APPROVED MINUTES OF THE MEETING

January 21, 2010

Project: Alaskan Way Viaduct Seawall Replacement

Phase: Design Update

Figure 1: North Portal Options 1 and 2

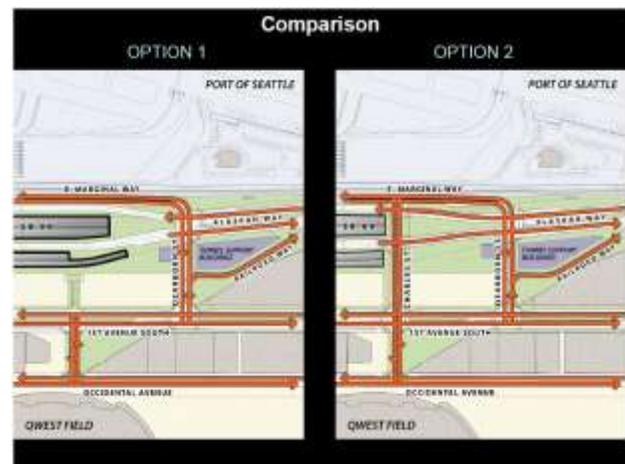
In the north portal area, how will pedestrians go north across Aurora?

On Harrison, when you stand at the tunnel, will that be a horrible place to stand?

Lots of our comments pertain to details that go beyond today's presentation. Concerning the north portal, one of the tools that can be used to slow traffic is a circuitous approach. Look for opportunities at the south portal to decompress people in a geometric fashion. More acknowledgement and awareness of signage will be helpful in the future.

Pedestrian connections will be on both sides of 6th Ave to the north of the entry ramp only. Pedestrians looking to cross over Aurora will have to cross at one of the streets south of the tunnel entrance. The entrance and exits in the vicinity will not allow for pedestrian crossings due to the elevation changes. Aurora width is 92-feet wide and becomes wider. We have not finalized this design. We would like to maintain 14-foot sidewalk widths throughout.

There are some potentially interesting views, though noisy. There would be an opportunity to create viewpoints. This access point is similar to entering a hill as opposed to dropping down.

Figure 4: South Portal Area Overview Sketch

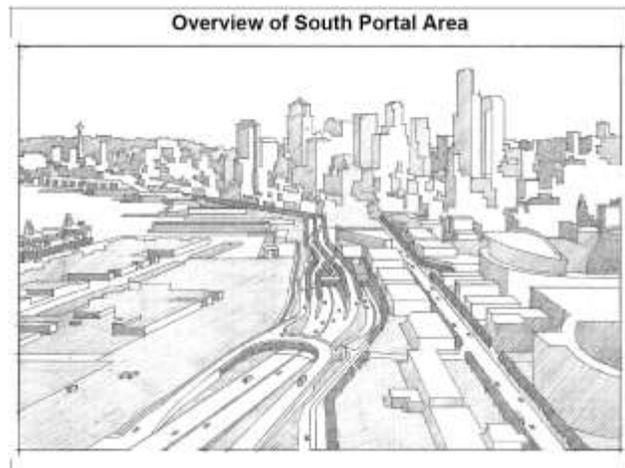
- There is concern about the quality of the pedestrian promenade proposed to be located in the footprint of the viaduct ramps along Railroad Way (running diagonally between Alaskan Way and 1st Ave S) because it is pinched at First and S. Dearborn St. Considering the volumes of pedestrians and the potential for views between the stadiums and the waterfront, please consider how this pinch point might be remedied. Addressing this problem will also help maximize the open space potential by better linking the plazas proposed on both sides of S. Dearborn St.

- The stairway on the “little H” overpass that links pedestrians to the rest of the south portal is considered essential by the Commission. This element provides a unique design opportunity for a larger gesture.

There seems to be a plaza opportunity near the south portal between Dearborn St. and Charles St.

I had a reaction to intersection of 1st and Dearborn and question whether the corner could be expanded to create a clearer path along Railroad Way S.

On the Little H, (overpass) concerning the stairway, I think this is important to keep.

We believe there may be utility issues. Transmission lines run through this area and limit our options. We don't know the programming yet for some of these sites. We will be looking at this. This design is evolving. We are also looking to possibly move Dearborn St. slightly to the south which would change our options at this site.

We can look at the view corridor along the Railroad Way. It is all a part of the ongoing discussion. Meaningful open space is critical.
